WATER QUALITY M E M O R A N D U M Utah Coal Regulatory Program

RE: 2010 2nd Quarter Water Monitoring, Hidden Splendor Resources, Inc., Horizon Mine, C/007/0020 WQ10-2, Task ID #3565

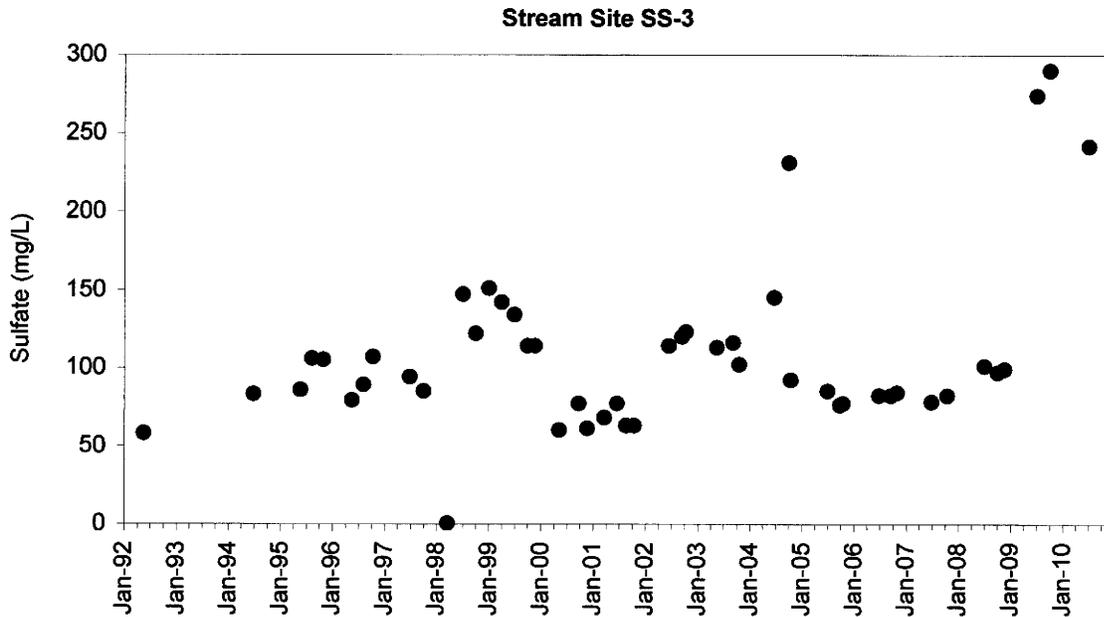
The sulfate concentration reported for site SS-3 (Jewkes Creek below mine) on June 30, 2010 was reported at 241.5 mg/L, which is more than double the average value of 108 mg/L (std. deviation = 53.4 mg/L). Sulfate concentrations at station SS-3 are variable, but appear to have been elevated during recent sampling events (see plot below).
